ADDENDUM NO. 1

Date November 9, 2023
Eugene School District 4J
Gilham Elementary School Roof Replacement 2024

Gilham Elementary School Roof Replacement 2024

6 FALL PROTECTION ANCHOR AT AREA 'N' AND 'W'
S201 23002.02-06 SCALE: 1 1/2" = 1'-0"

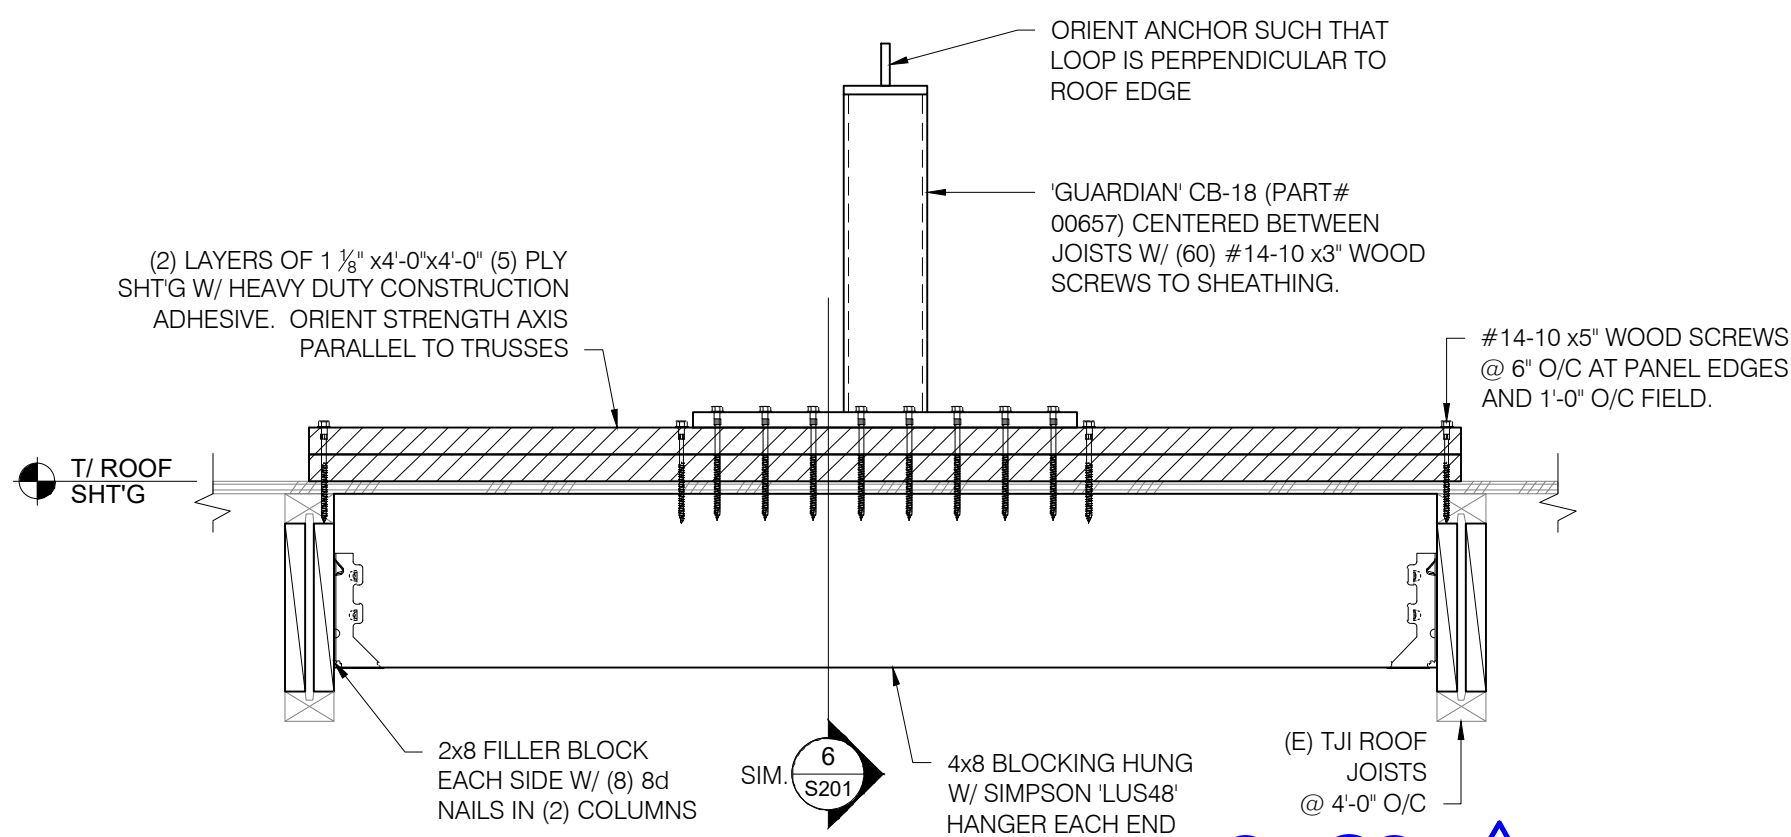
1.12	<i>Drawing Sheet S201</i>	Replace sheet with attached revised Sheet S201. Note the following changes: <ul style="list-style-type: none">• Added Addendum No. 1 revision identifier.• Clarified detail names.

3 GL BEAM REPAIR
S202 23002.02-12 SCALE: 3/4" = 1'-0"

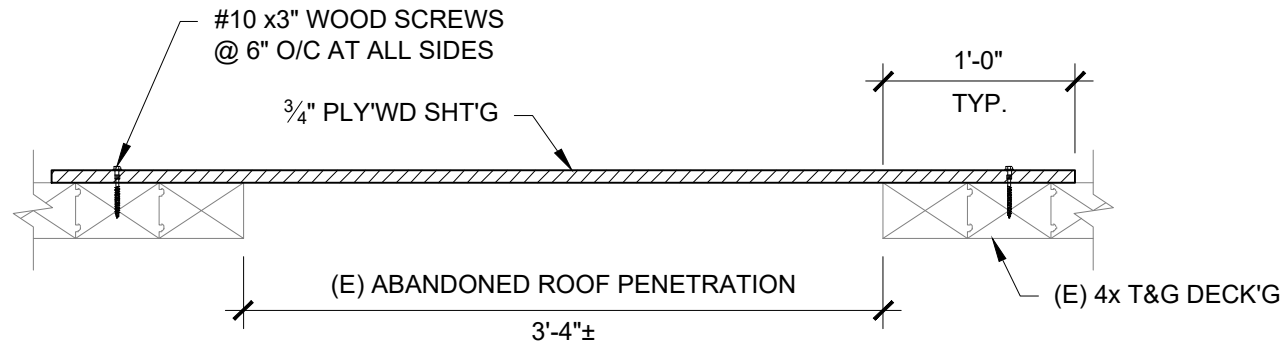
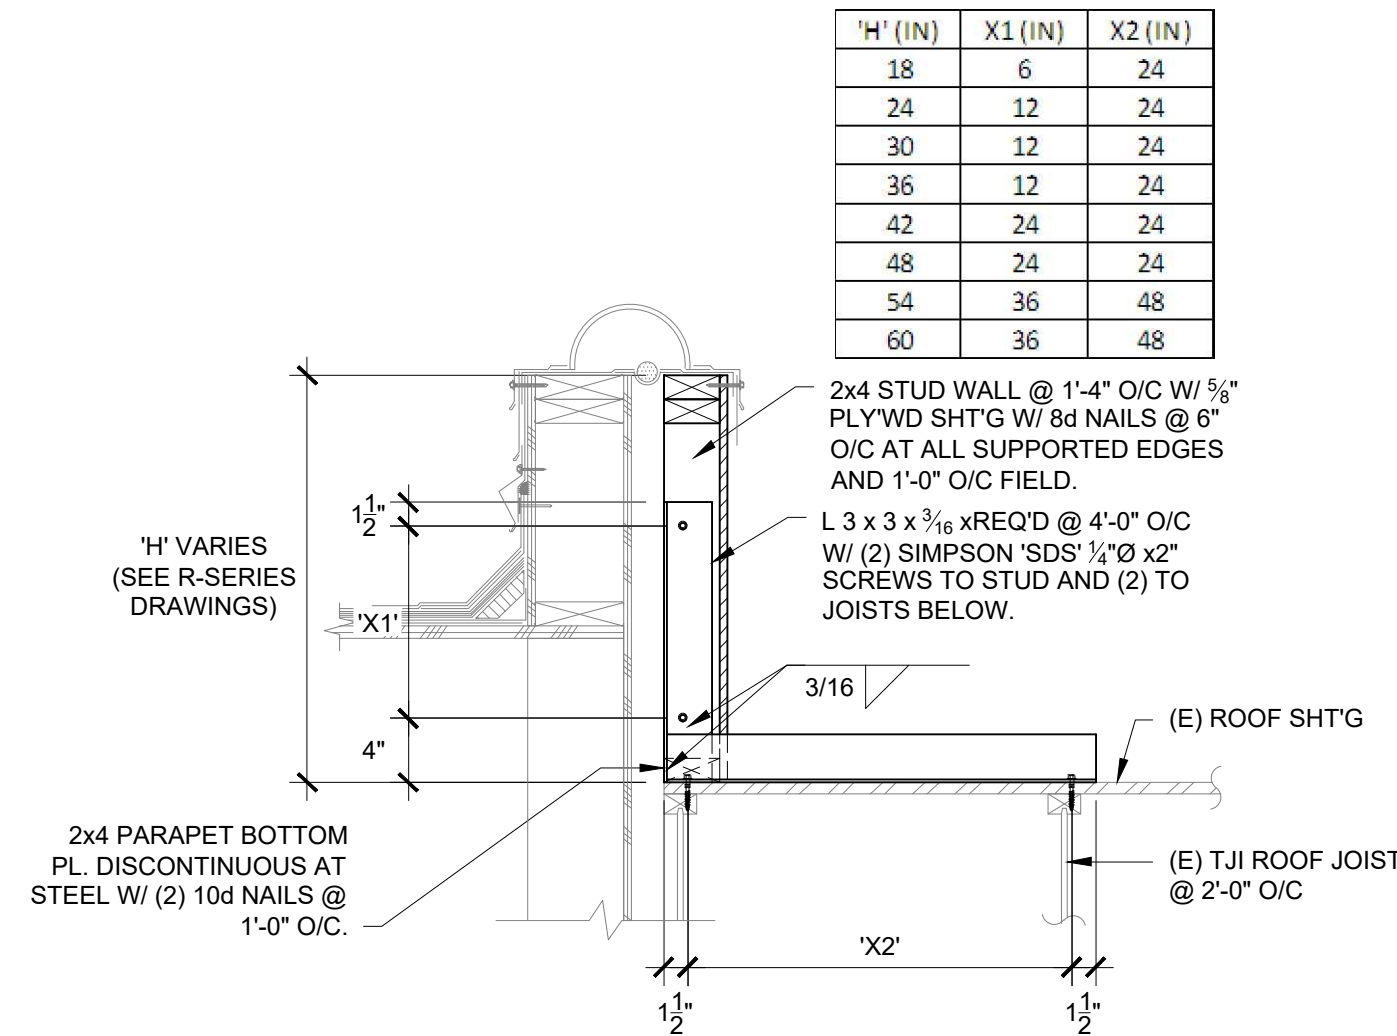
1.13	<i>Drawing Sheet S202</i>	Replace sheet with attached revised Sheet S202. Note the following changes: <ul style="list-style-type: none">• Added Addendum No. 1 revision identifier.• Clarified extent of beam repairs.
